PRESENTATION ON PEER REVIEW,  
SUPPLEMENTAL INVESTIGATION AND  
SEEPAGE ANALYSIS  
FOR  
KINGSTON FOSSIL PLANT, DREDGE CELL  
KINGSTON, TENNESSEE

Prepared for  
Tennessee Valley Authority

Prepared by  
GeoSyntec Consultants

April 2005

# Case 2 (Blow-out condition) TIMES Output

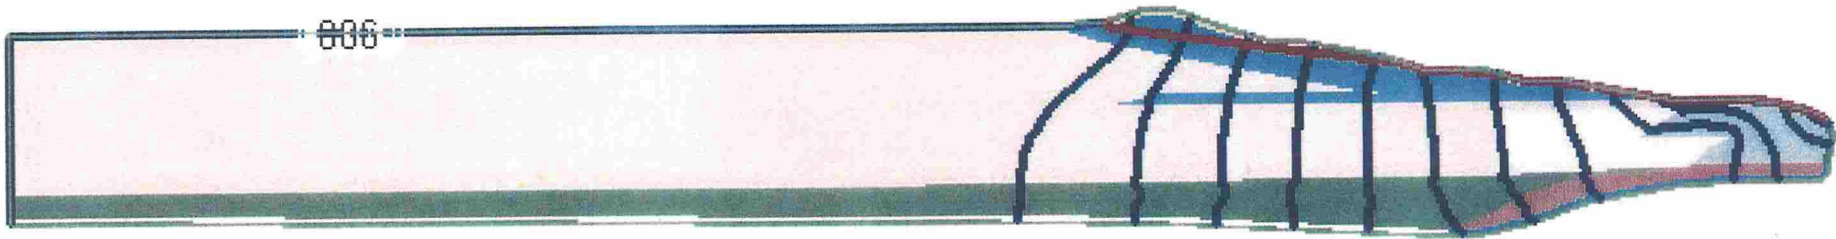
- The computed hydraulic gradient at the lower portions along exit face 'A' is greater than the critical hydraulic gradient, confirming the likelihood that piping and blow-out will occur consistent with that observed in field.
- Model-predicted location of blow-out (i.e., exit face 'A') coincides with blow-out location observed in the field (i.e., at elevation 766 ft MSL).
- Qualitative assessment of analysis results performed for blow-out condition (Case 2) are consistent with visual observations reported in the field (e.g. wet spots on slope, vegetation on downstream slope and estimated quantity of seepage through the blow-out area).

## Proposed Improvement

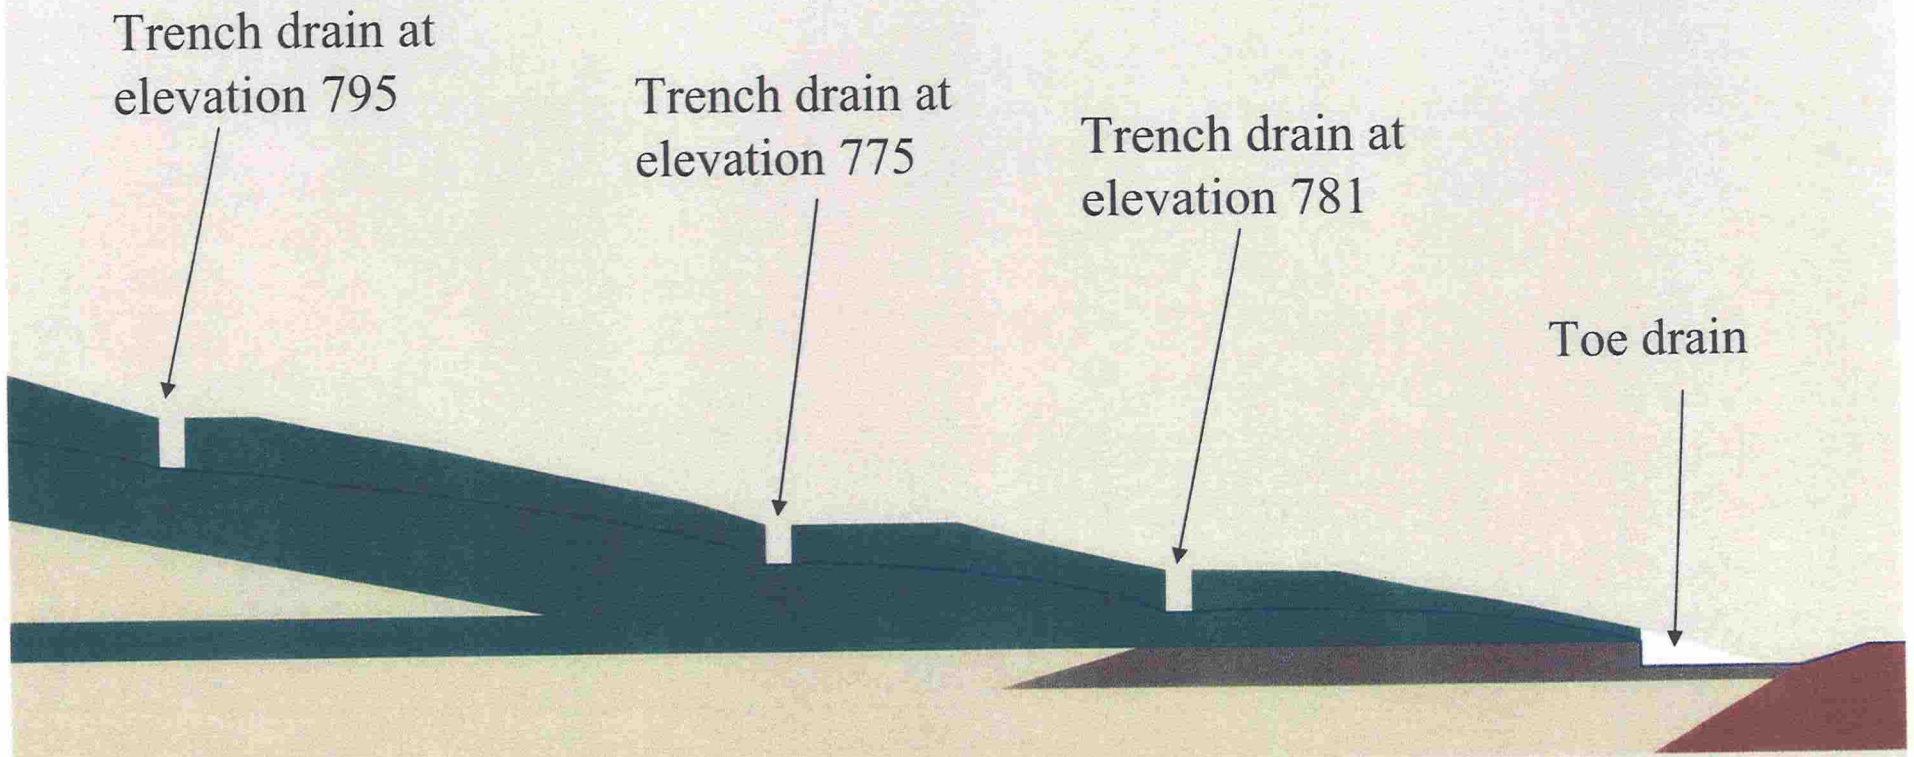
The proposed improvements for the lower portion of the dredge cell side slope consists of the following major items:

- A trench drain constructed to a minimum depth of 6 feet deep from the existing bench at EL 795 feet
- A trench drain constructed to a minimum depth of 5 feet deep from the existing bench at EL 781 feet
- A trench drain constructed to a minimum depth of 5 feet deep from the existing bench at EL 775 feet
- A buttress type toe drain pipe with minimum rip rap lining to the existing drainage channel adjacent to Swan Pond Road.

All trench drains have an assumed width of 3.0 feet.

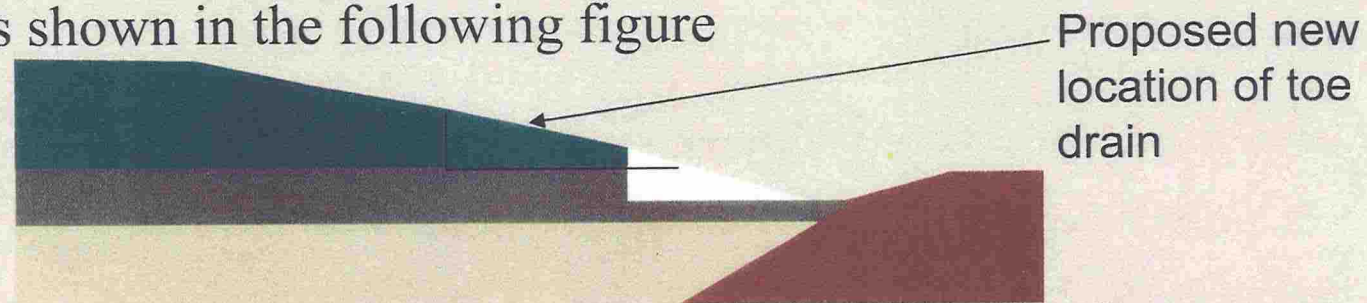
- Based on analytical results for Case 3, the proposed improvements are expected to lower the phreatic surface away from the face of the lower portion of the side slope significantly reducing the future potential for piping and providing an acceptable factor of safety.
- An alternative to the proposed improvement include relocating the toe drain is shown in the following figure

- In addition to the seepage analyses presented herein, GeoSyntec recommends that Parsons review/re-evaluate the slope stability analysis to assess the factor of safety against global stability under future conditions.
- The independent seepage analyses prepared by GeoSyntec are in general agreement with the analyses prepared by Parsons.
